Subject: USNRC Docket No. 72-1014; TAC No. L22221
HI-STORM 100 Storage Application
Resolution of Public Comments

In response to your request, we are pleased to enclose herewith draft copies of change pages comprising proposed Revision 10 to the HI-STORM 100 Topical Safety Analysis Report (TSAR). The proposed changes are identified with revision bars in the margin. These changes include those discussed with the NRC in a conference call held on January 28, 2000 to address public comments received during rulemaking as well as other minor editorial changes and clarifications. Please note that changes to drawings are not included with this submittal as discussed with the NRC project manager previously.

DRAFT PROPOSED REVISION 10

HI-STORM TSAR CHANGES

FIG. 3.A.19 Tipover Scenario: Impact Force Time Histories

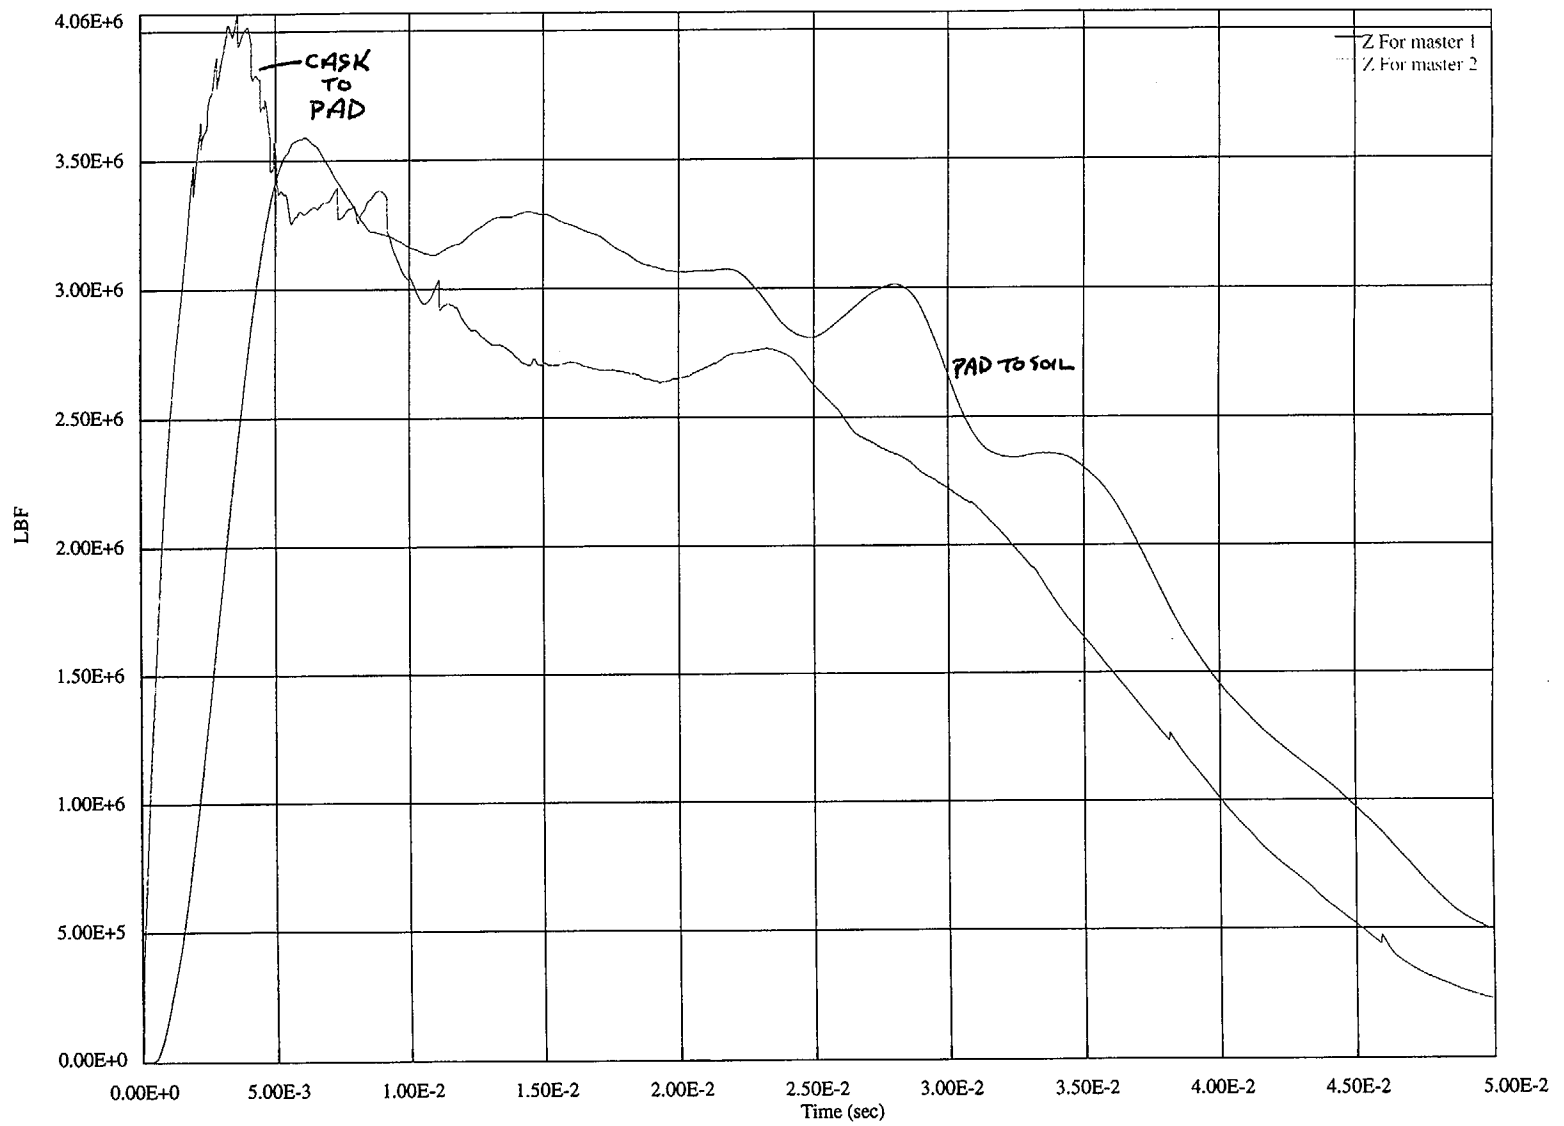
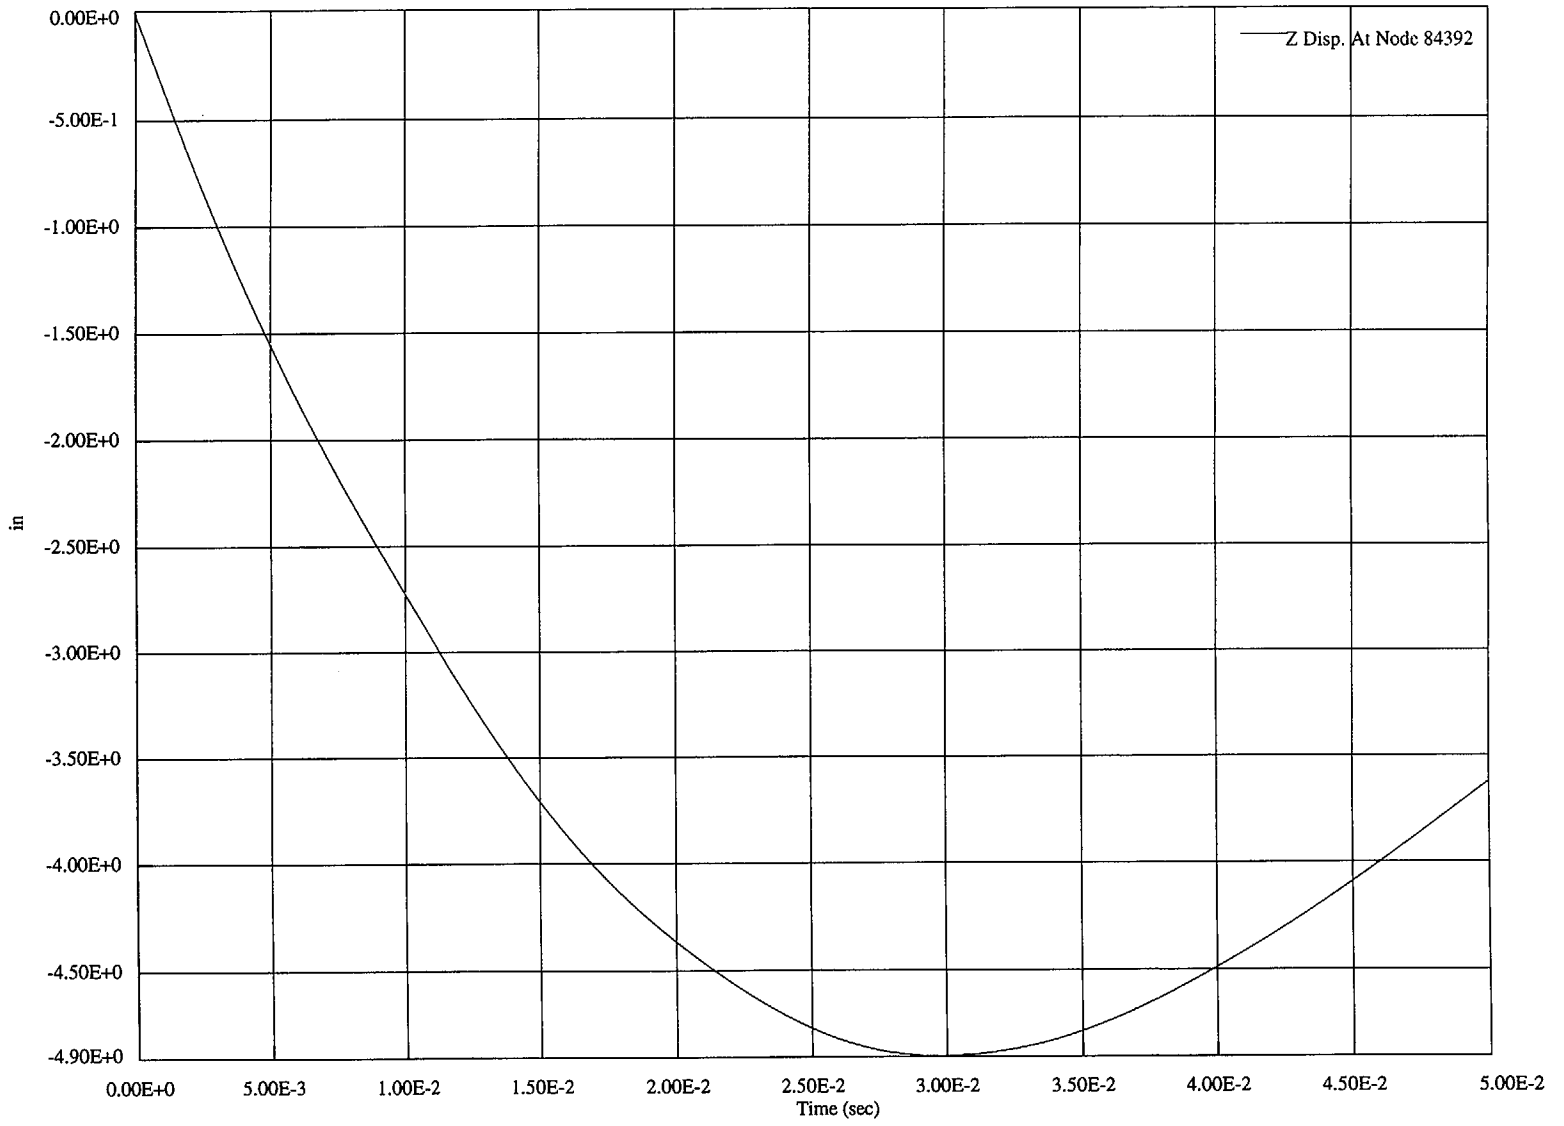
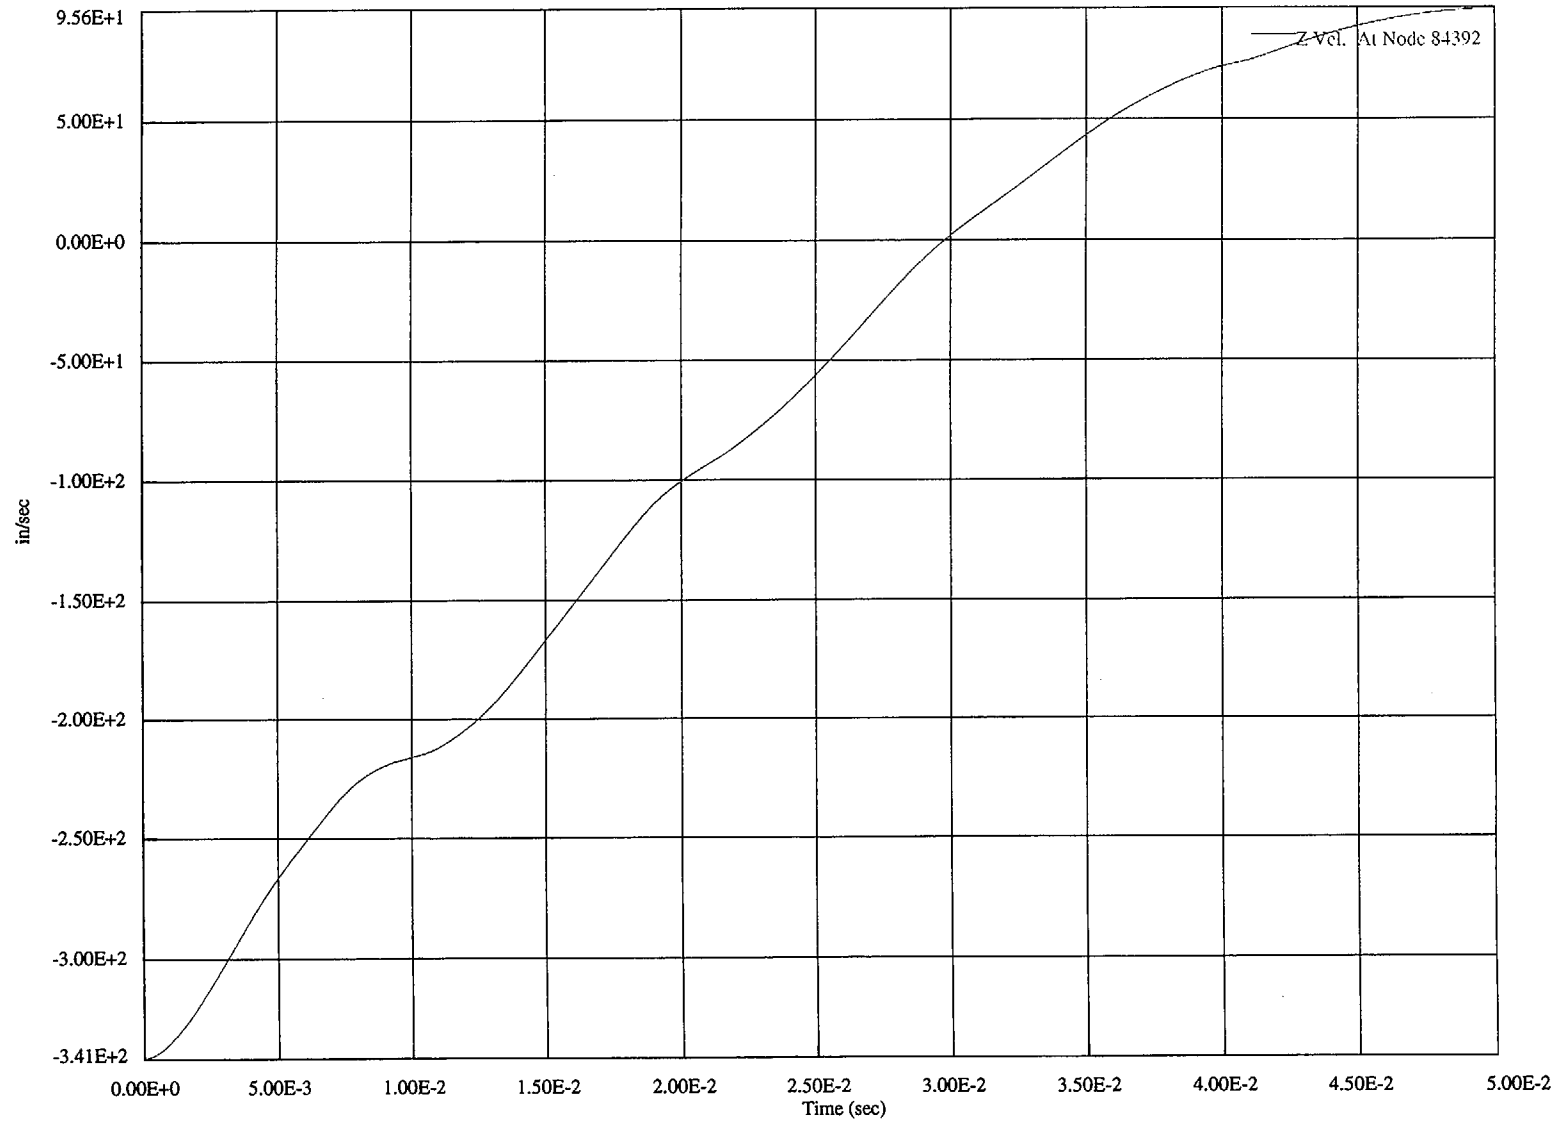
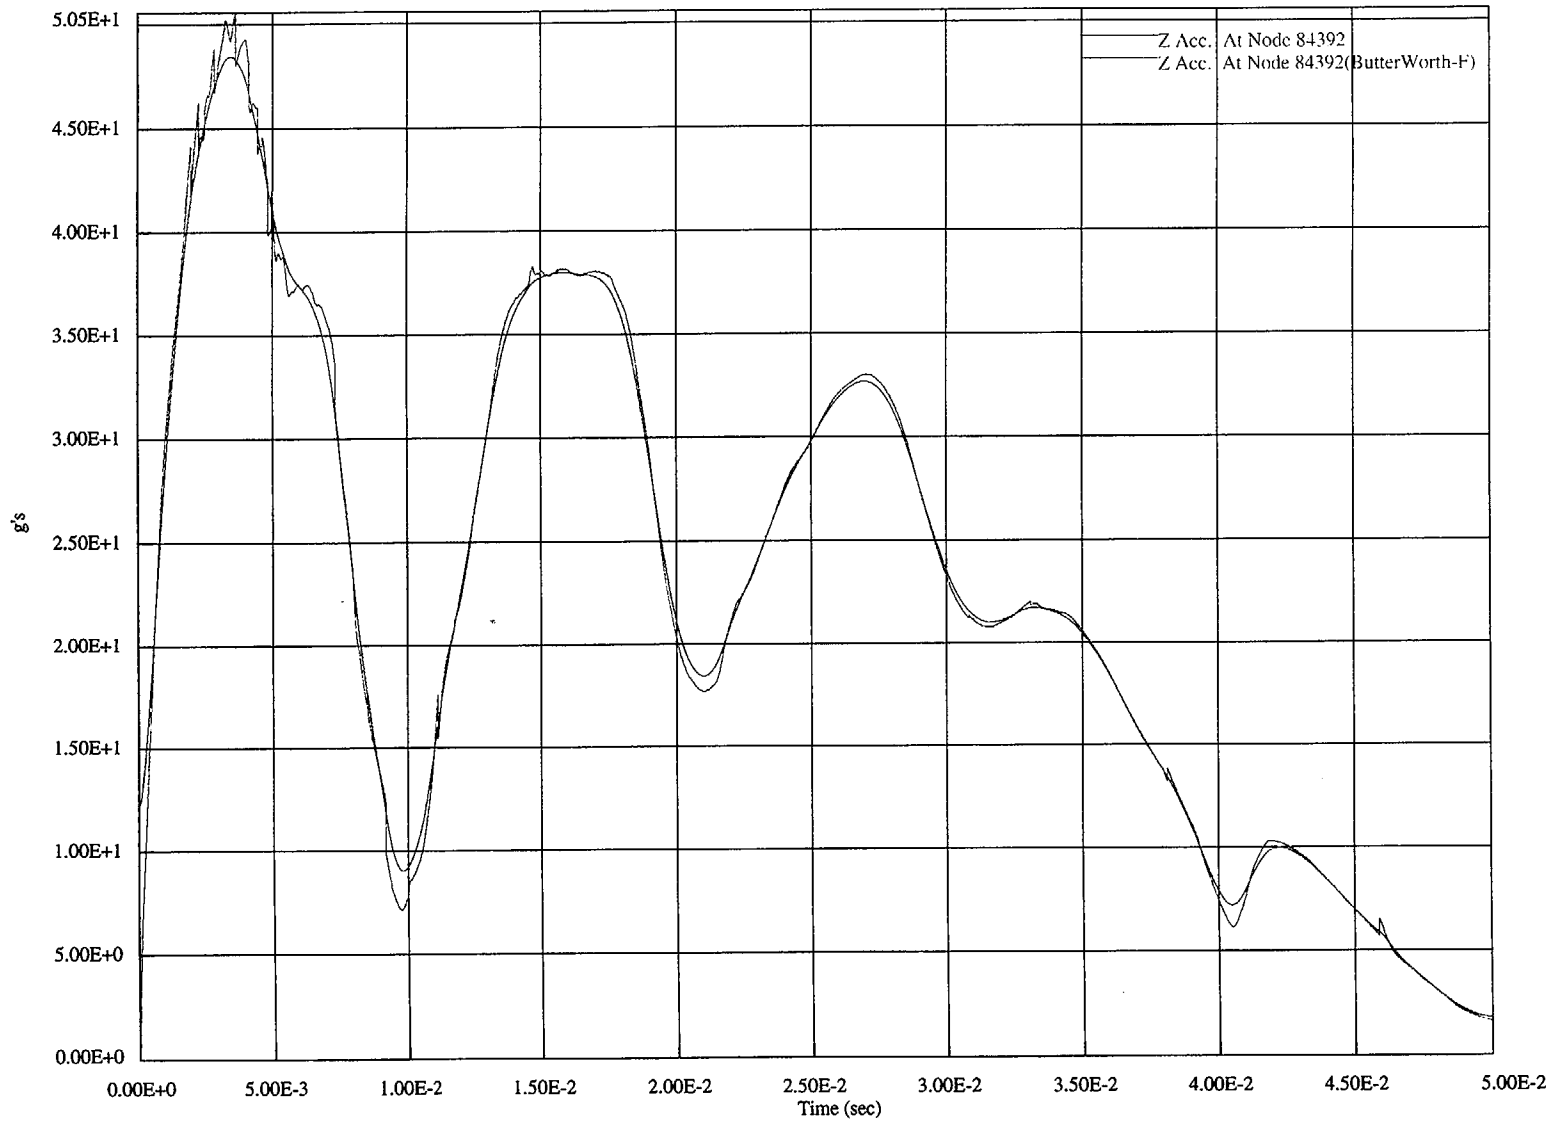
In the interest of absolute technical accuracy, we have also revised the results of the cask tip-over events in TSAR Table 3.A.4 even though the deceleration values change only in the second decimal place. Recent discovery of a data input discrepancy in the LS-DYNA3D input file led us to re-run the tip-over cases which, as proposed revised Table 3.A.4 shows, produced infinitesimal changes in the results. Associated TSAR Figures 3.A.19 through 22 are also proposed to be replaced.

Drop Event	Max. Displ (in)	Impact Velocity (in/sec)	Max. Acc. (g's)	Acc. Pulse Duration (msec.)
End-11"	0.696	92.20	44.13	2.96
Tipover Cask Top ¹	4.958 4.903	341.3	48.48 48.41	9.40 9.76
Tipover (Basket Top)	4.417 4.368	304.03	43.19 43.12	--
Tipover (with Increased Initial Clearance) Cask Top ¹	4.998	341.3	48.52	10.0
Tipover (with Increased Initial Clearance) (Basket Top)	4.452	304.03	43.22	--
